REMARKS

Amendments to the Drawings

ANNOTATED MARKED-UP DRAWINGS

Fig. 1a

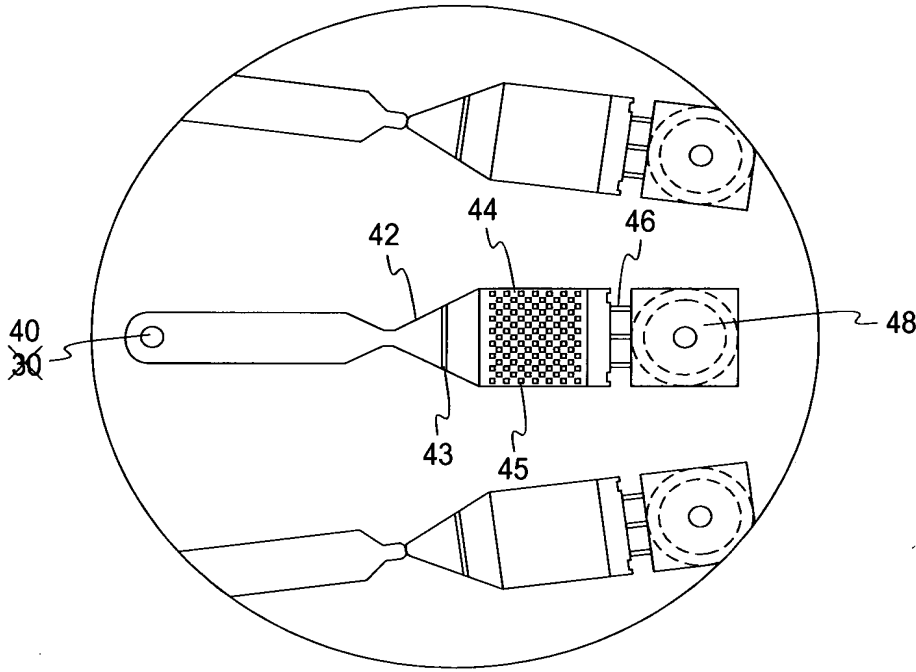
The drawings have been objected to as lacking certain features of the invention. In response, revisions have been made to Figures 1 and 5, as shown in the enclosed amended sheets. The original Fig. 1 includes a bottom view of the inlet port, passageway, inlet chamber and vent, as shown in a vertical sectional view in Fig. 2. The center portion of Fig. 1, now Fig. 1a; has been enlarged in new Fig. 1b and one of the array of posts is shown in Fig. 1c. In Fig. 5 the passageway between 10 and 12 is shown as dotted, since it is below the top of the microfluidic chip being illustrated. The specification has been amended for consistency with amended drawings.

Please replace Fig. 1 with the enclosed two replacement sheets
